MEMORANDUM

SUBJECT: Construction of Boat Docks and Retaining Walls

609 River Road, Boat Dock - File# SP-95-0032DS
4400 Rivercrest, Boat Dock - File# SP-95-0023DS
4318 Rivercrest, Boat Dock - File# SP-95-0024DS
2705 Westlake Drive, Shoreline Improvements
- File #SP-95-0012DS

SUBJECT: Construction of addition to existing pier, at

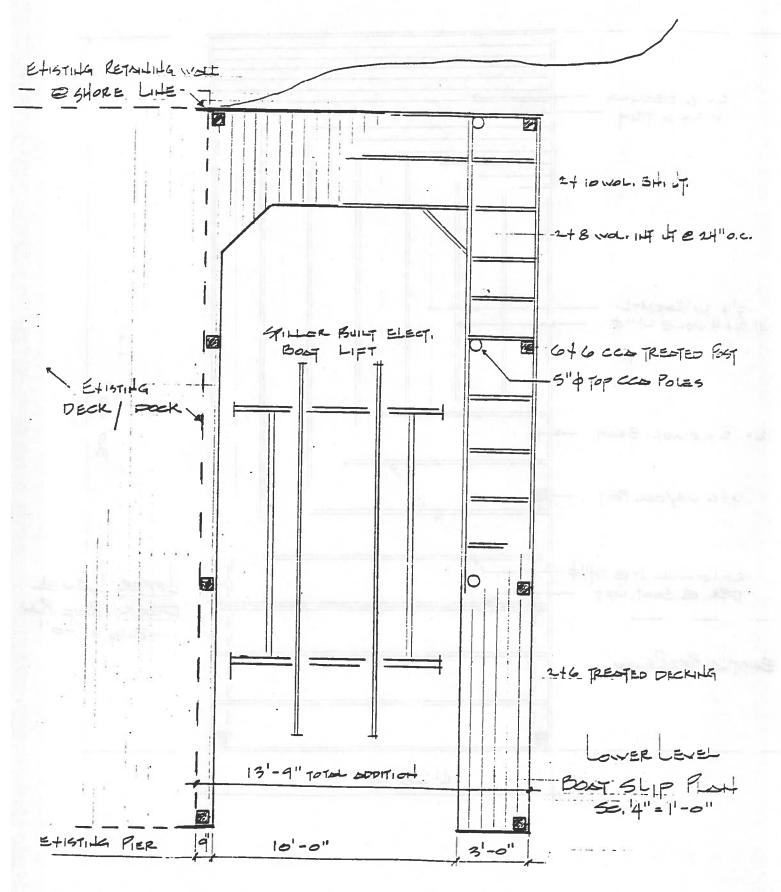
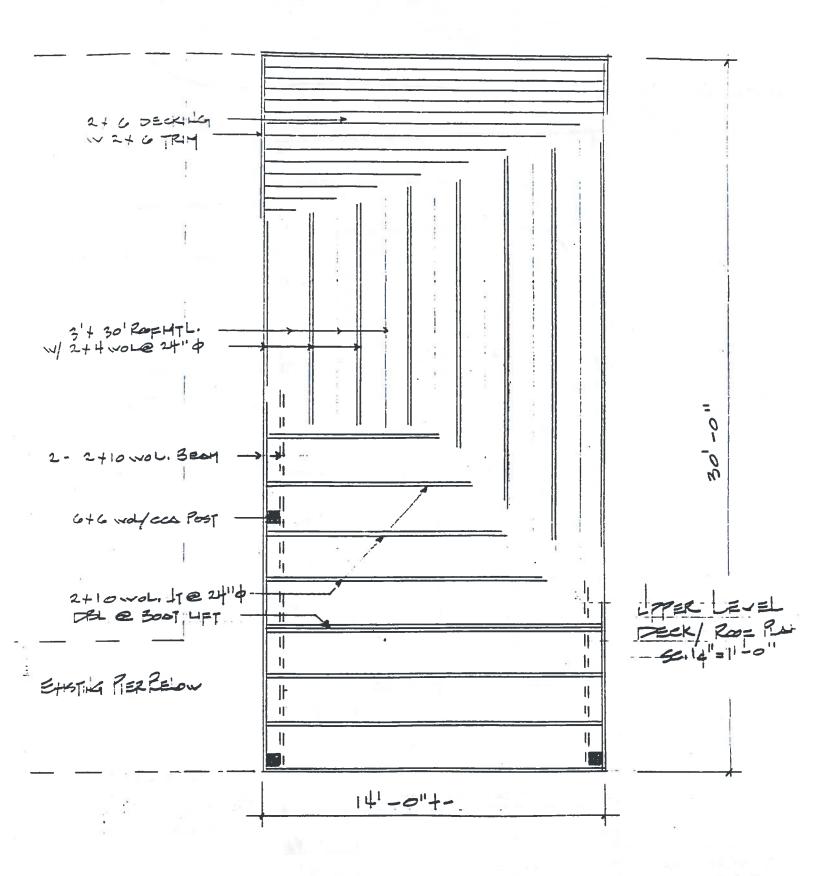
HOTE: HO STARS UP TO ROF / DECK // HO HALLD RAIL OF THIS TIME
